May 15, 2019
BOARD OF COUNTY COMMISSIONERS
ORANGE COUNTY, FLORIDA

Y19-751-CH/Addendum #4

**CONNECTOR ROAD FROM HILTON DRIVEWAY TO APOPKA VINELAND ROAD
INTERSECTION IMPROVEMENTS**

Bid Opening Date: May 30, 2019

SHEET NO.
 59

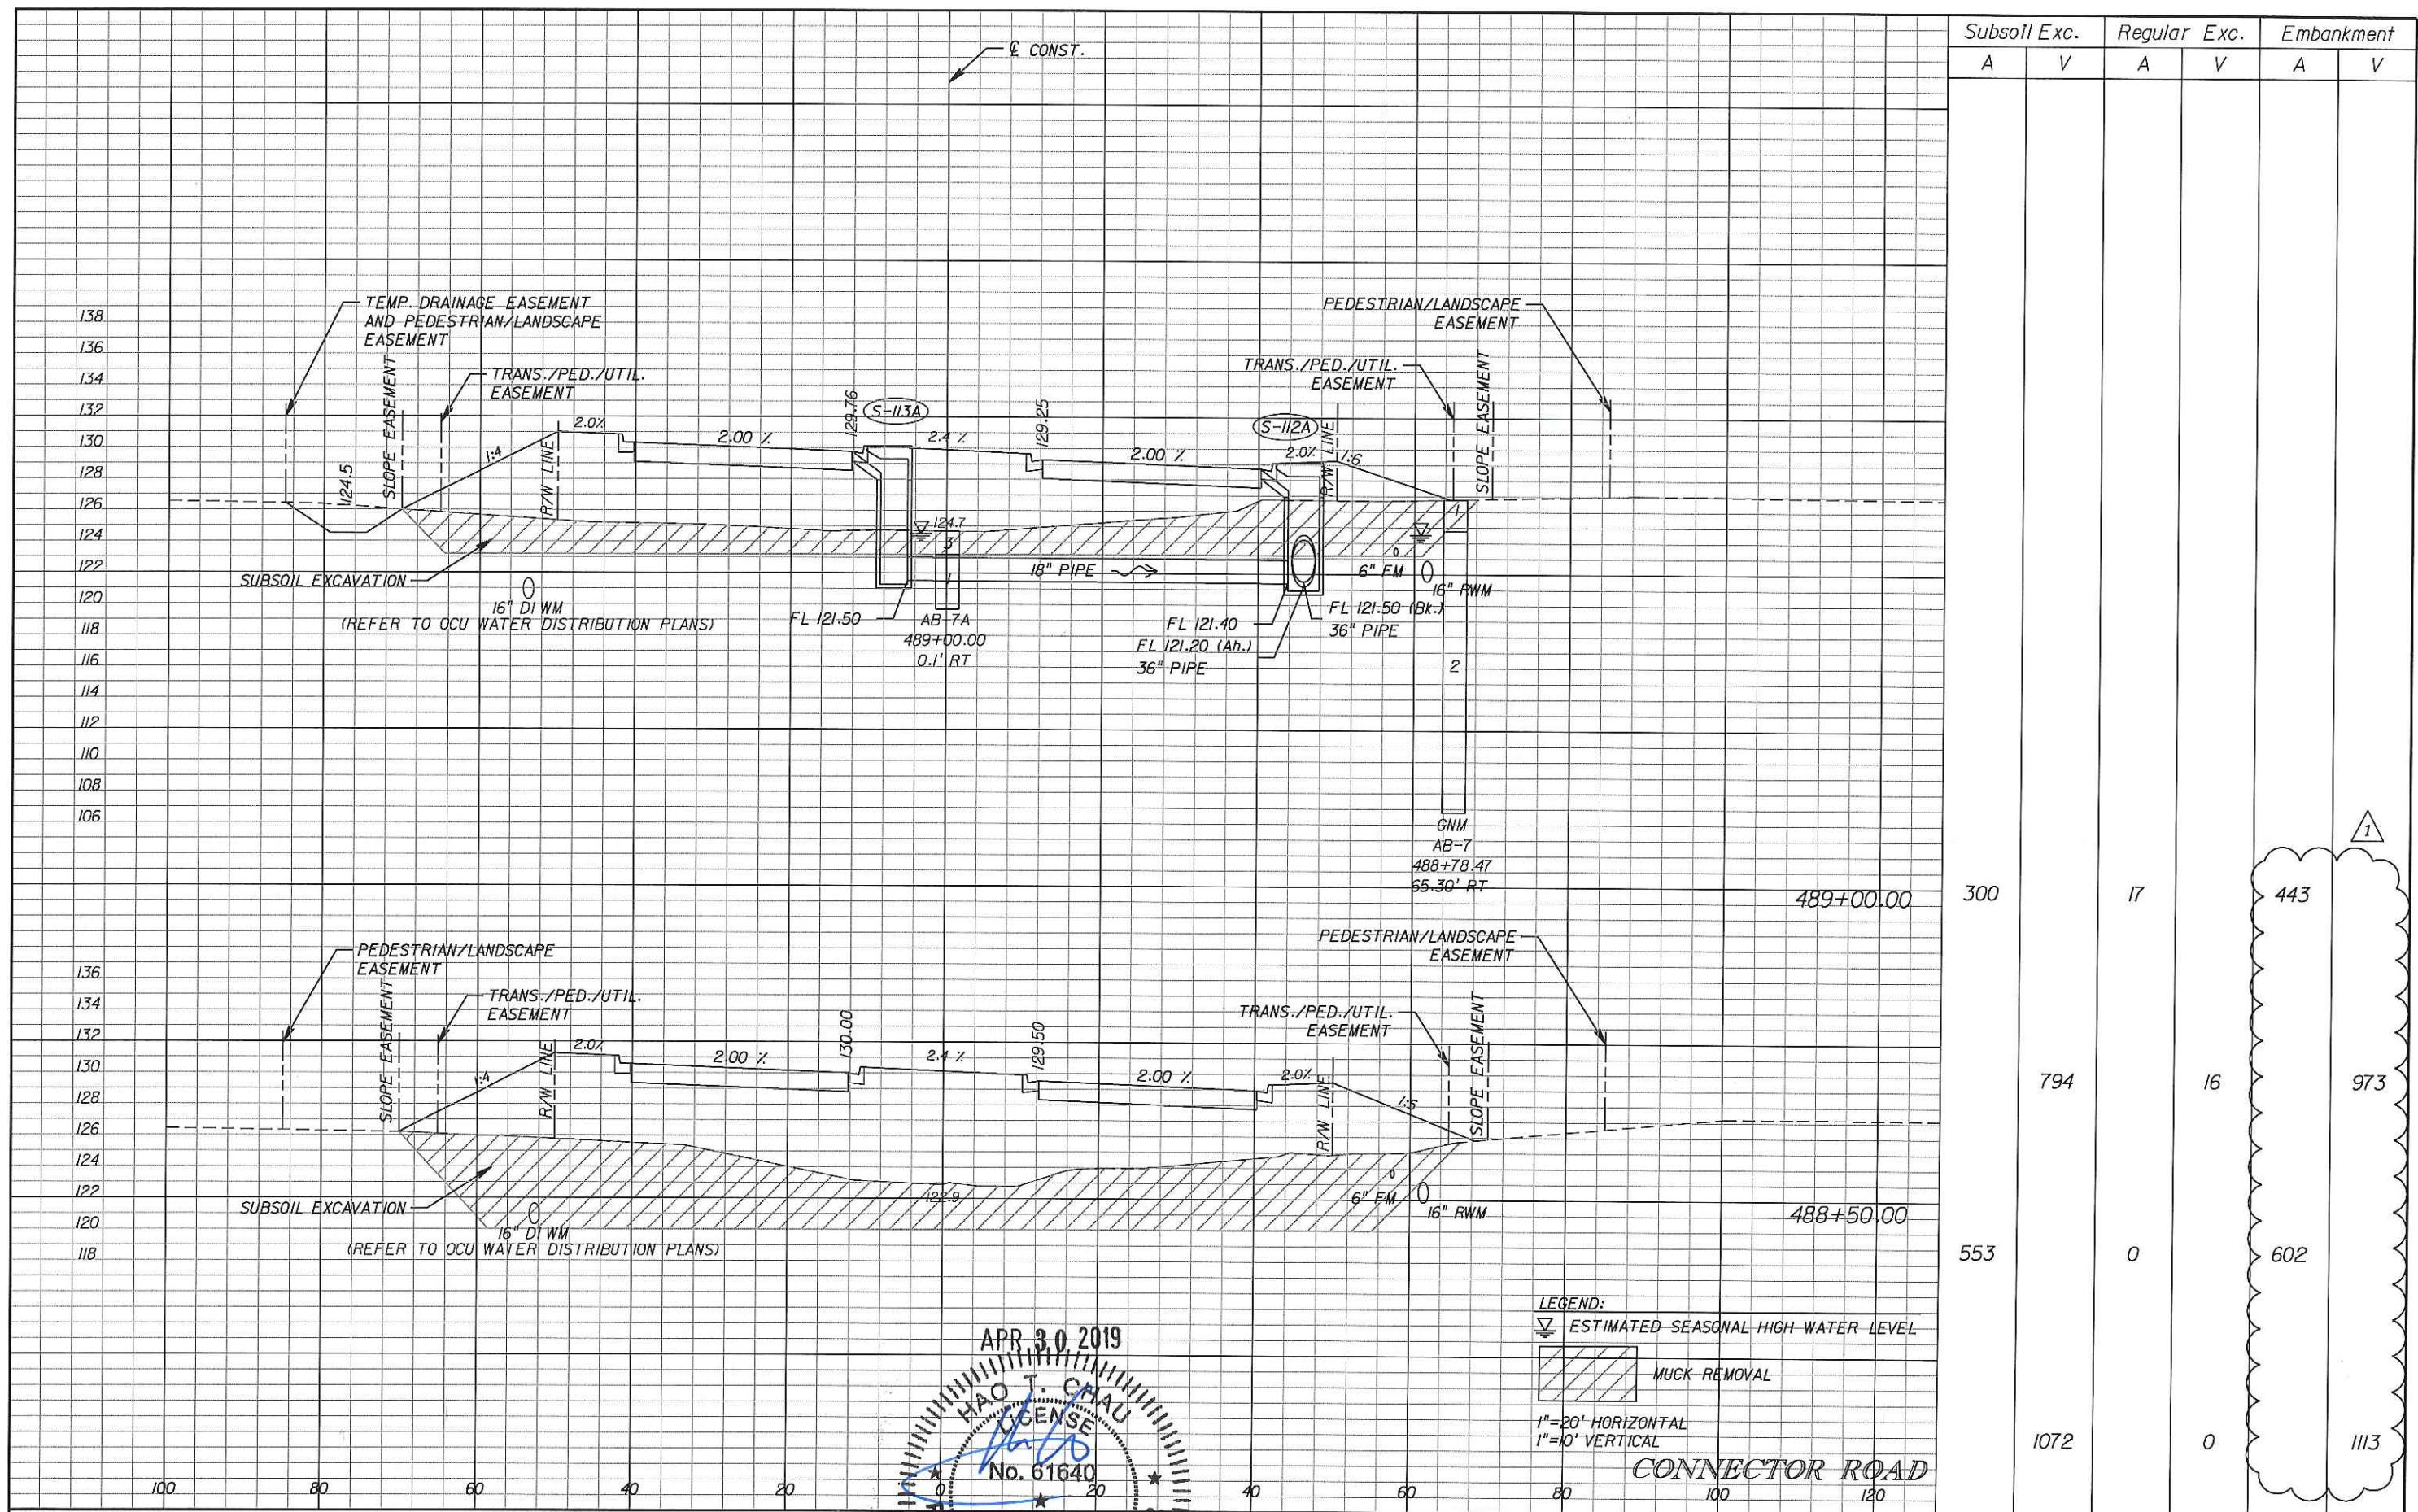
DATE	BY	DESCRIPTION	DATE	BY	DESCRIPTION
04/30/19		1 REVISED EMBANKMENT QUANTITIES

SHEET NO.
 60

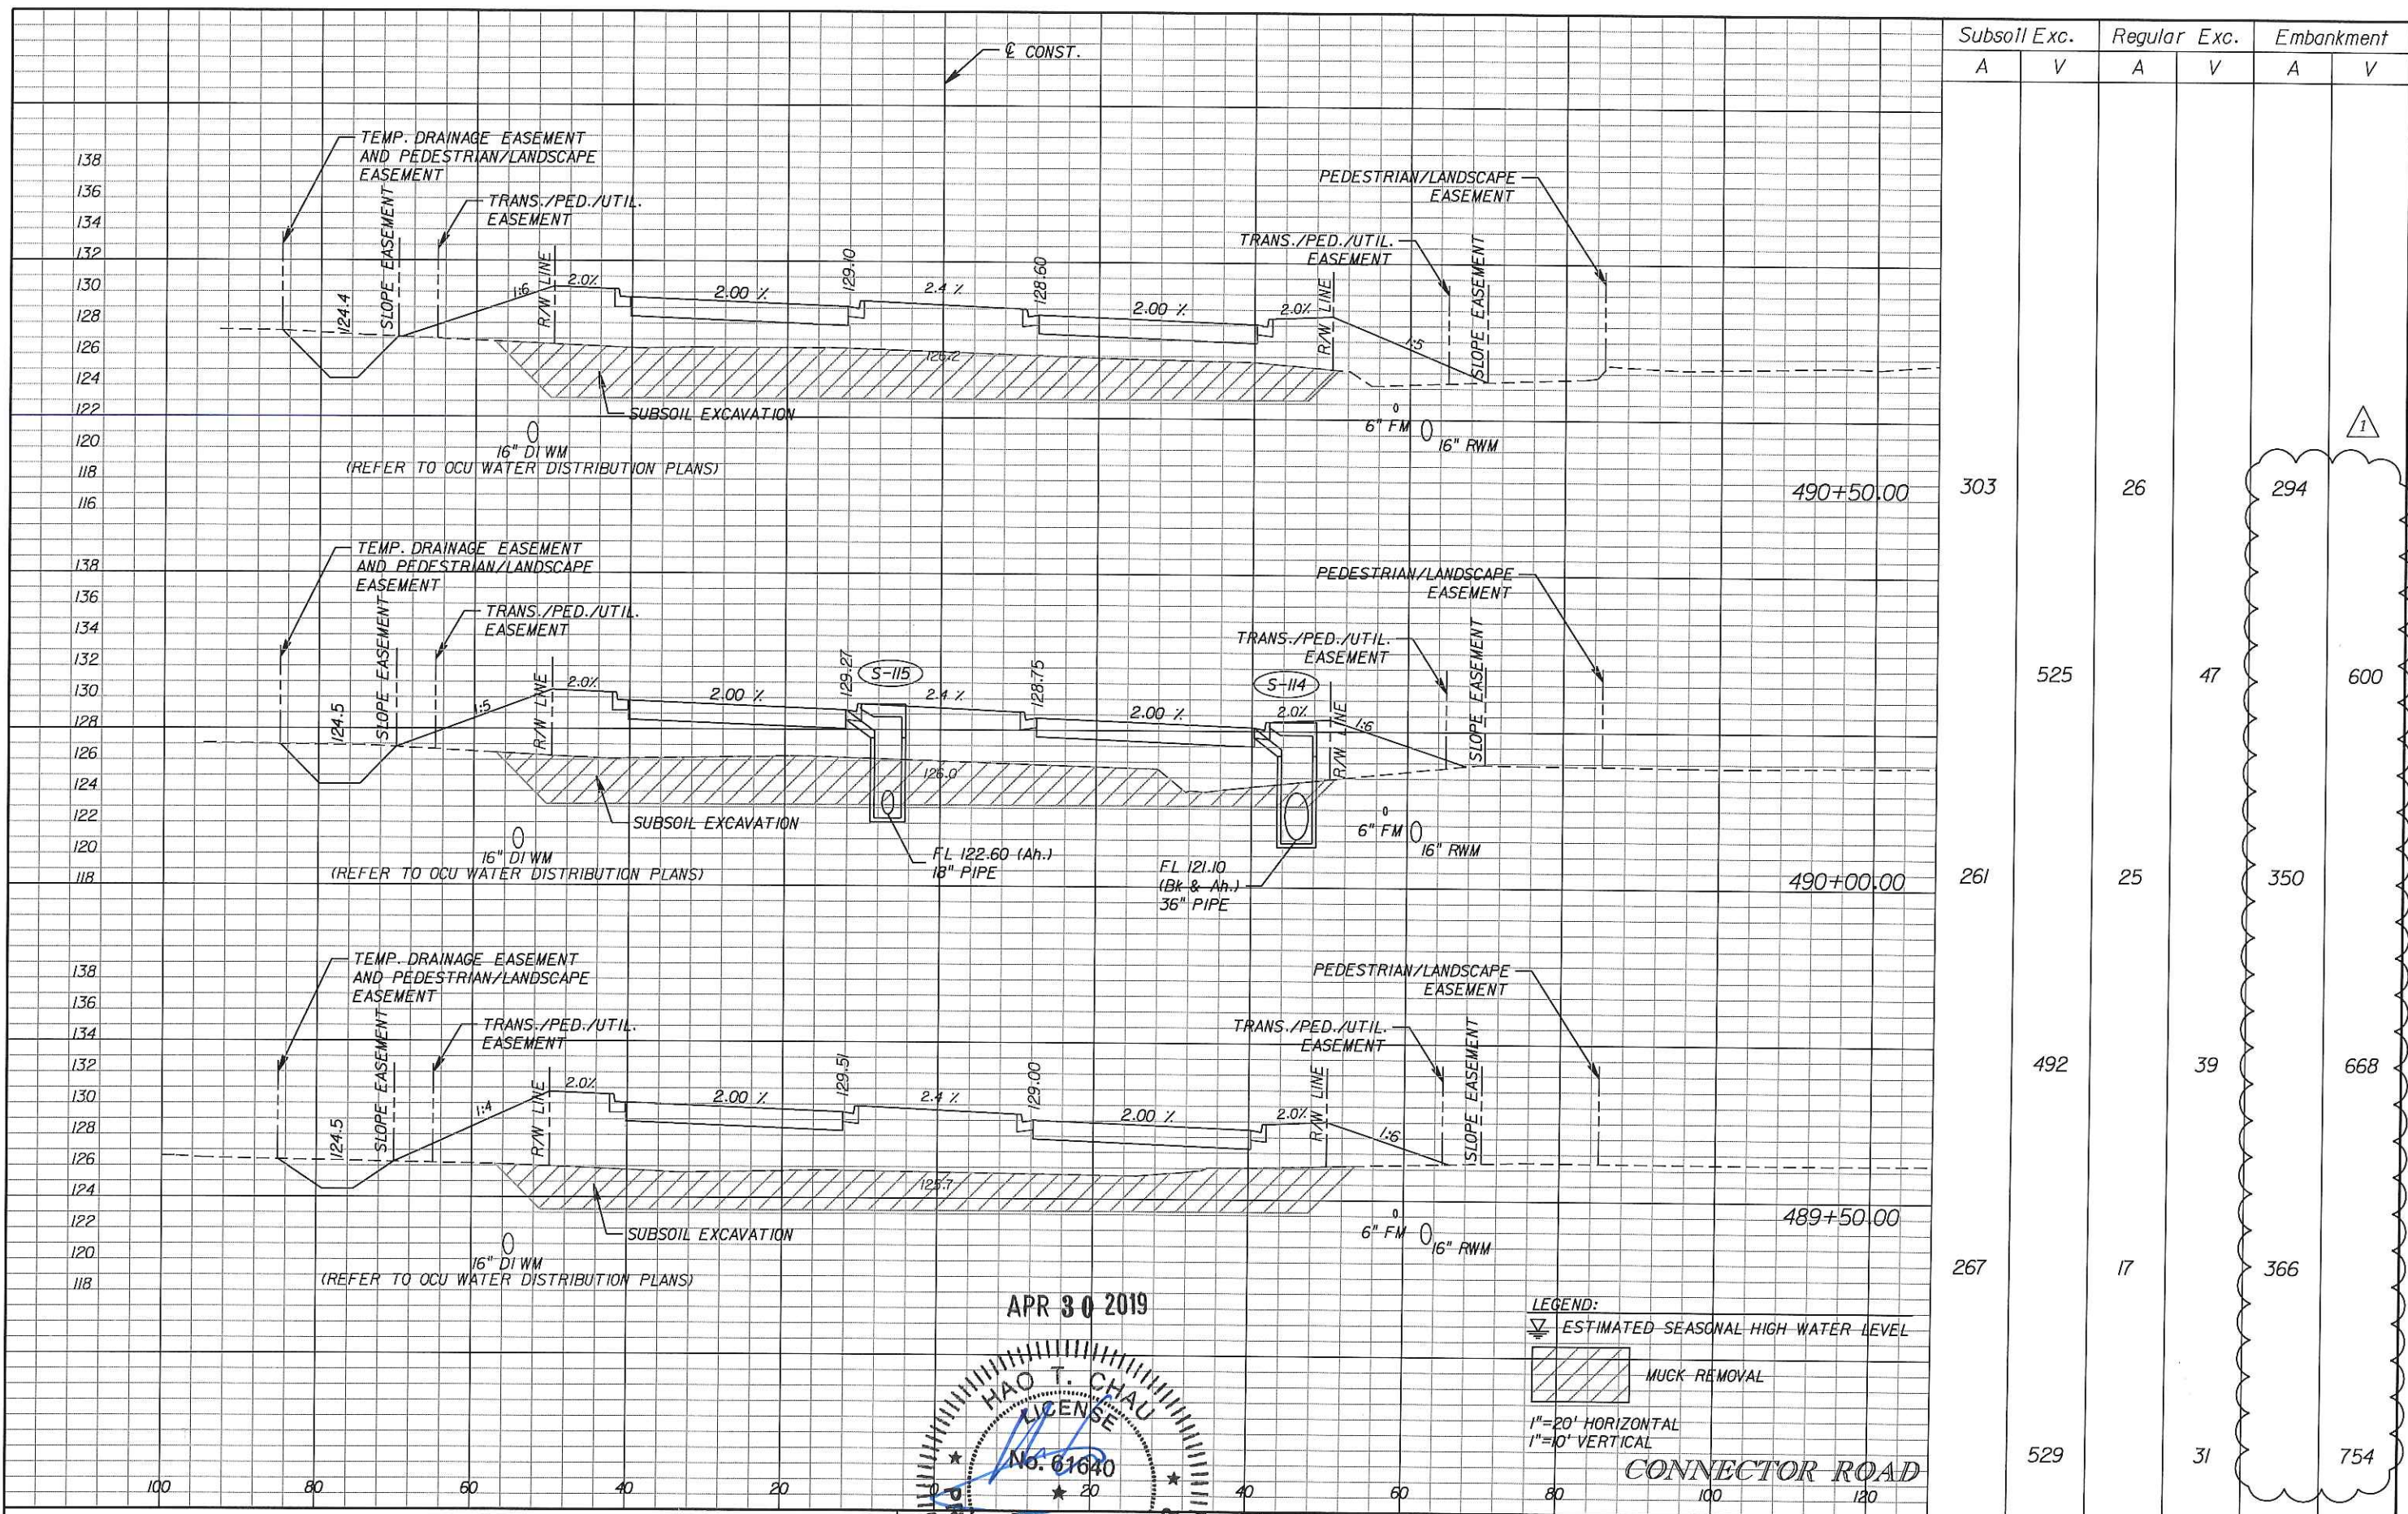
DATE	BY	DESCRIPTION	DATE	BY	DESCRIPTION
04/30/19	HAO J. CHAU	REVISED EMBANKMENT QUANTITIES

SHEET NO.
61

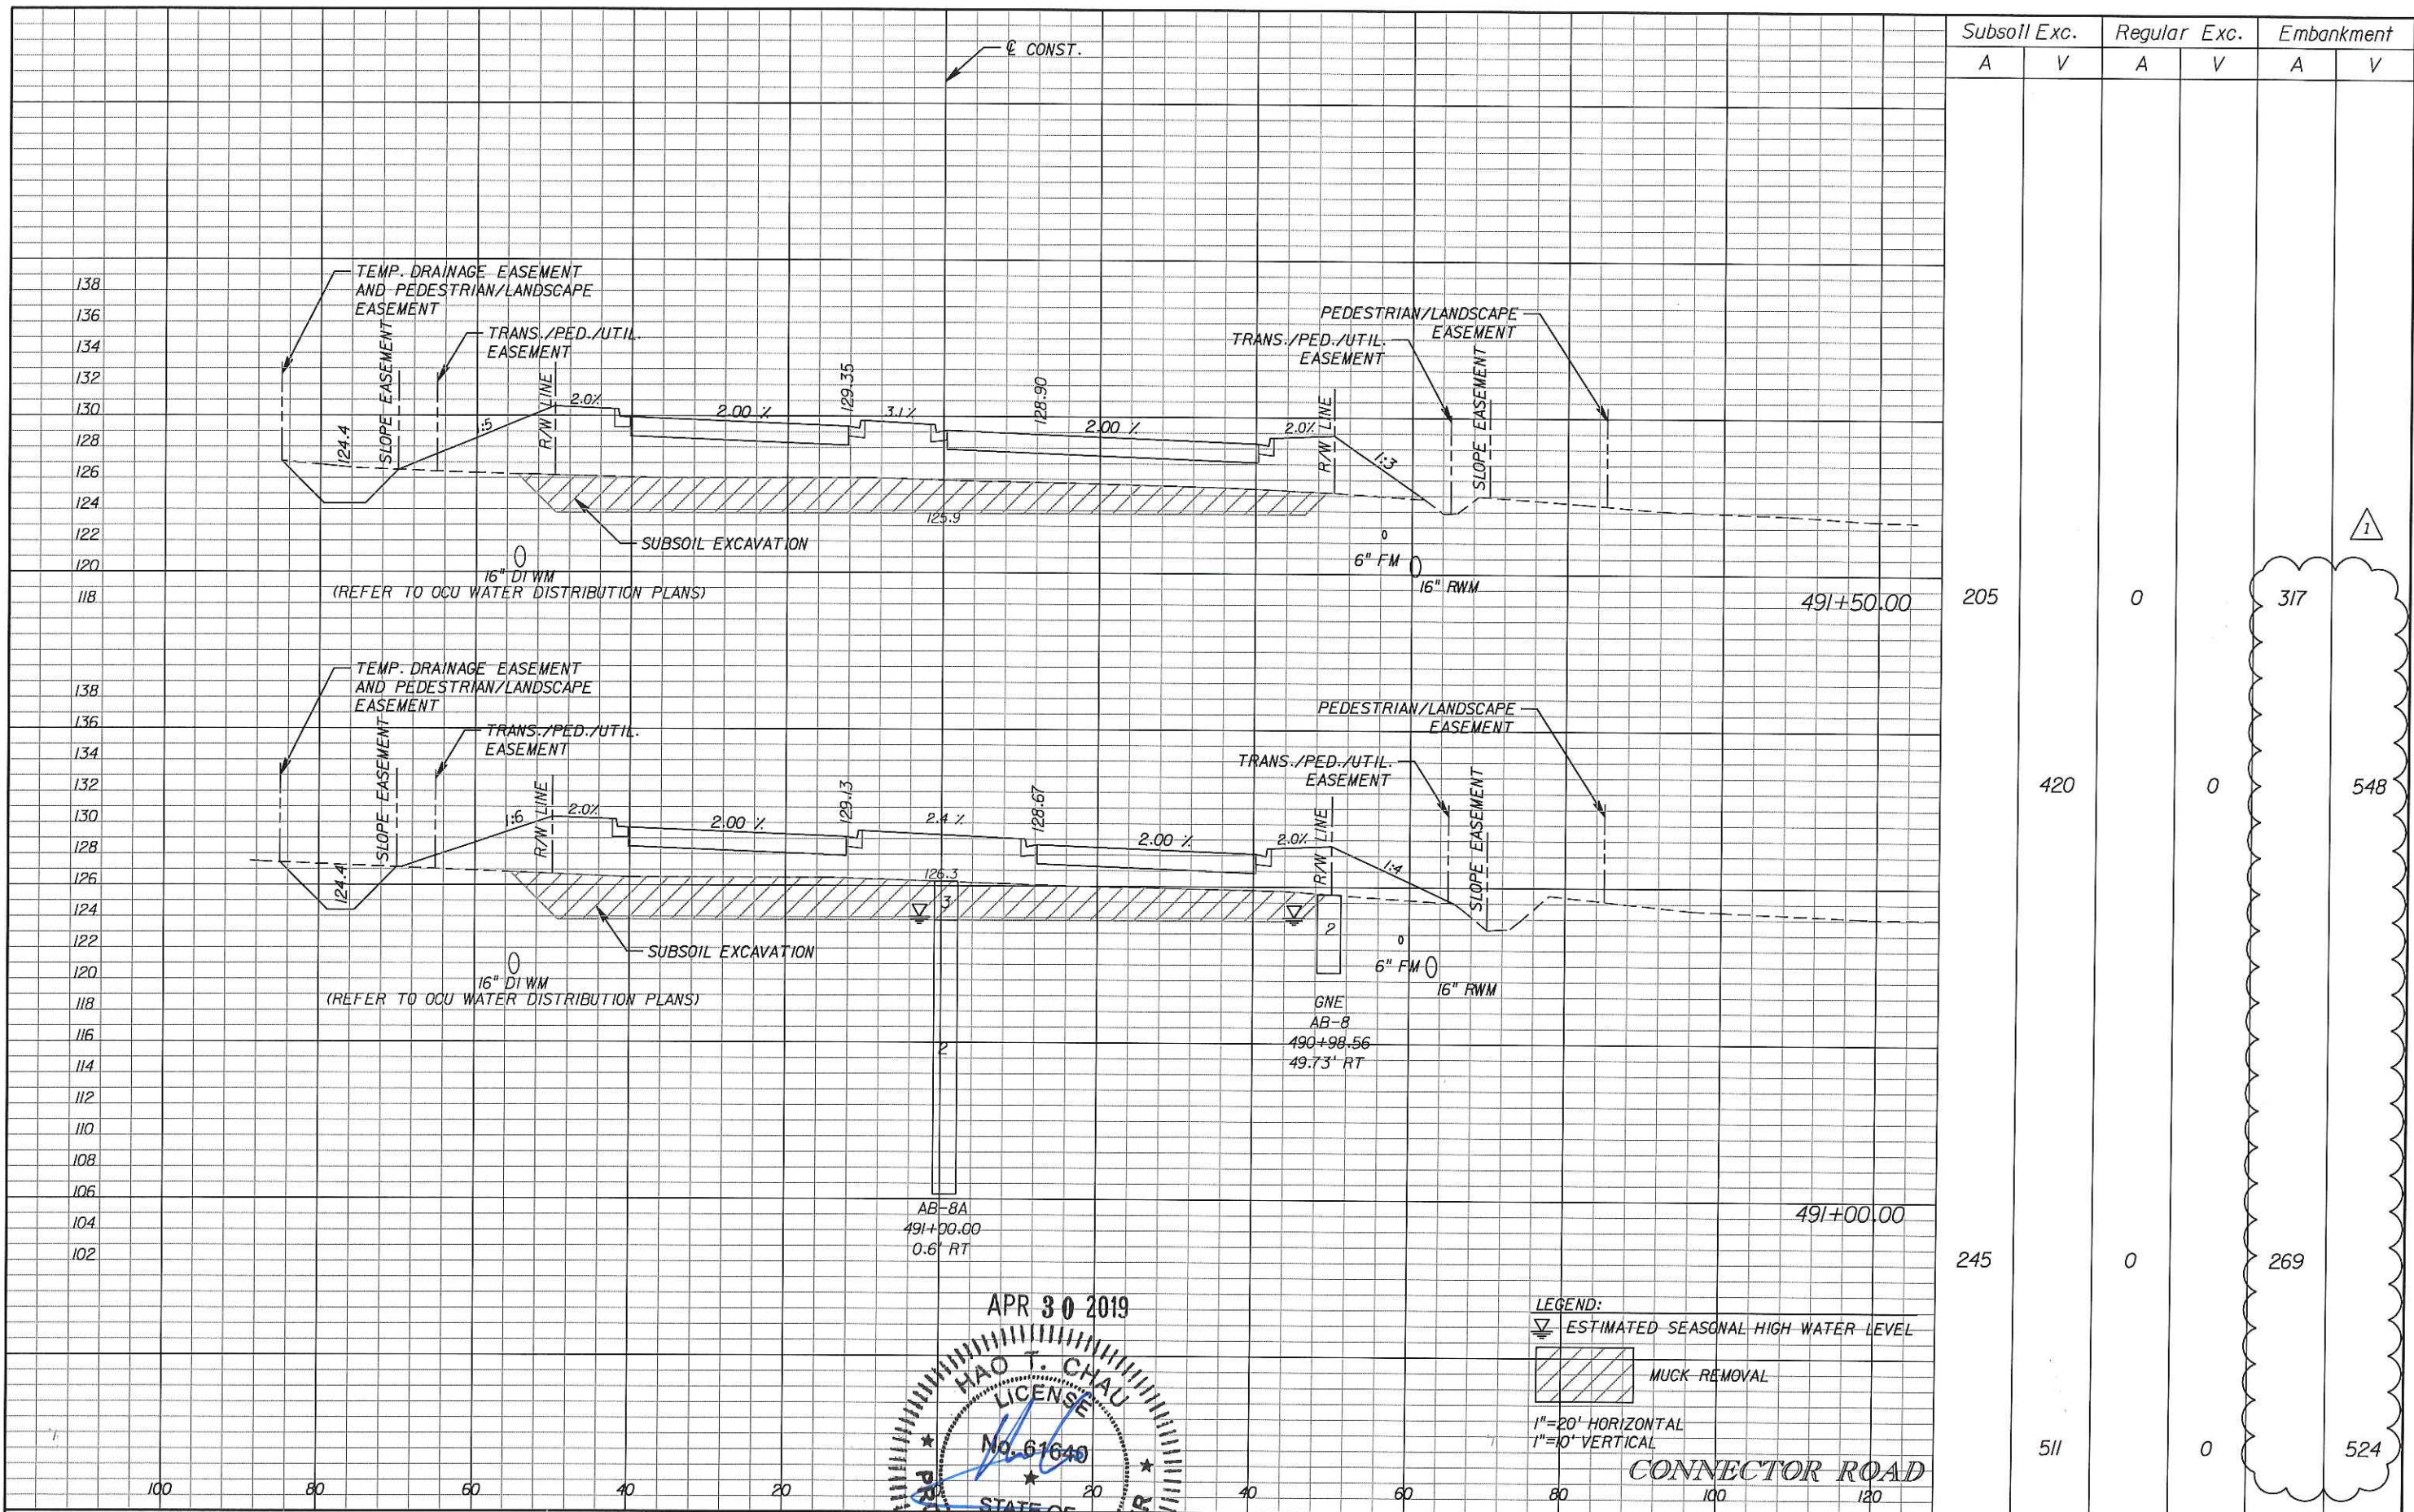
DATE	BY	DESCRIPTION	DATE	BY	DESCRIPTION
04/30/19		1 REVISED EMBANKMENT QUANTITIES
